CAROL PLANTATION SUBDIVISION, UNIT 6,
RESUBDIVISION OF LOT 728,
RESUBDIVISION OF LOT 2

APPLICATION NUMBER 8 DATE December 15, 2005

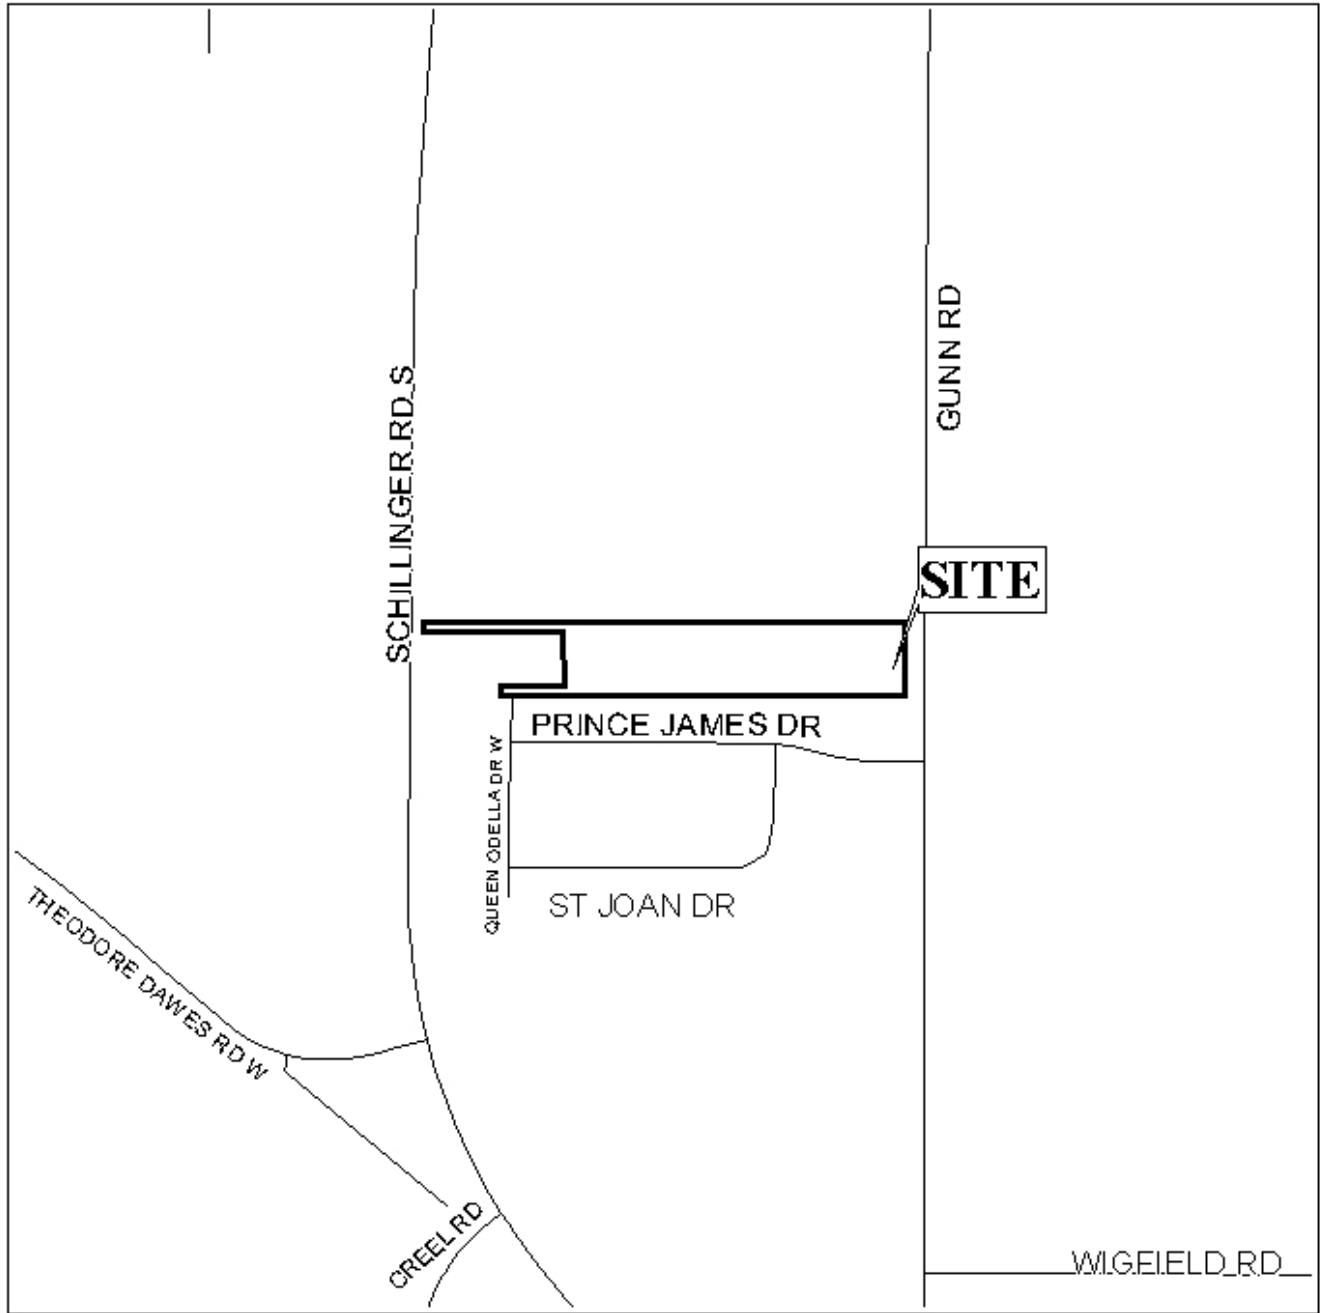
Proposed Lots 2, 4, and 5 would exceed the maximum depth allowed by the Subdivision Regulations (Section V.D.4), and would require a waiver of that section. In addition, four of the five lots would be flag-shaped, which is uncharacteristic of other properties in the area, and thus would not conform to Section V.D.1 of the Subdivision Regulations, which states: *"The size, width, depth, shape, and orientation of lots ... shall be appropriate to the location of the subdivision and the type of development and use contemplated."* Approval of this subdivision request could result in future requests for subdivisions with flag-shaped lots.

The site is located in the County; thus any lots that are developed commercially and adjoin residentially developed property must provide a buffer, in compliance with Section V.A.7 of the Subdivision Regulations. Additionally, a condition of the previous subdivision approval was that, in case of commercial development of lots fronting Queen Odella Drive (a graded, unpaved road), access to that residential street should be denied.

Proposed Lot 5 would only have access to Queen Odella Drive, and this provision could not be enforced; furthermore, because there are no land use controls in the County, this condition could not be used to prevent commercial development of proposed Lot 5; therefore the only way to maintain the intent of the original condition of approval is to deny the creation of a lot that only has access to Queen Odella Drive.

Based on the preceding, this application is recommended for denial for the following reasons: 1) three lots exceed the maximum depth ratio (Section V.D.4); 2) four lots would not conform to the characteristic shape of the surrounding area (Section V.D.1); and 3) there would be no way to satisfy the original condition of subdivision approval that would deny access to Queen Odella Drive to commercially developed property.
